Product Change Notice ** Ammendment**

Sub: Packaging changes for FCSSL110 and (~~FCSL150~~) FC4L110 series. Effective Immediately

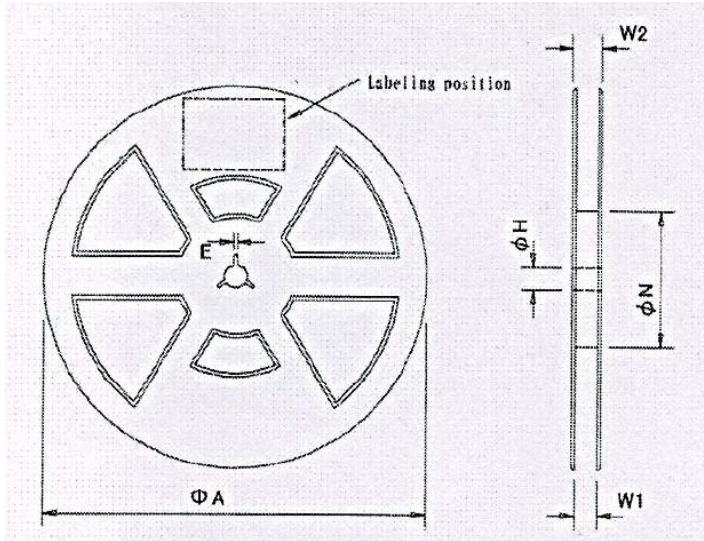
Ohmite announces dimensional changes to the reels of FCSSL110 and (~~FCSL150~~) FC4L110 series parts. The "A" dimension of the current reels are 330mm+/-2mm. This dimension will change to 180mm +/- 2mm. The "N" dimension will change from 100mm +/- 1mm to 21mm +/- 0.8mm. Existing stock of the old reel sizes will be shipped until stock is exhausted. Parts are stocked by value and wattage. There may be instances when two part numbers may arrive with two reel sizes due to stock demands. Old and New reel dimensions are listed below for reference.

A	12.992 (330±2.0)
H	0.512 (13±0.2)
E	0.079 (2.0 ±0.5)
N	3.937 (100±1.0)
W1	1.000 (25.4 ±1.0)
W2	1.157 (29.4 ±1.0)

Dimensions (mm)
ΦA	180±2.0
ΦH	13±0.2
E	2.0±0.5
ΦN	21±0.8
W1	25.4±1.0
W2	29.4±1.0
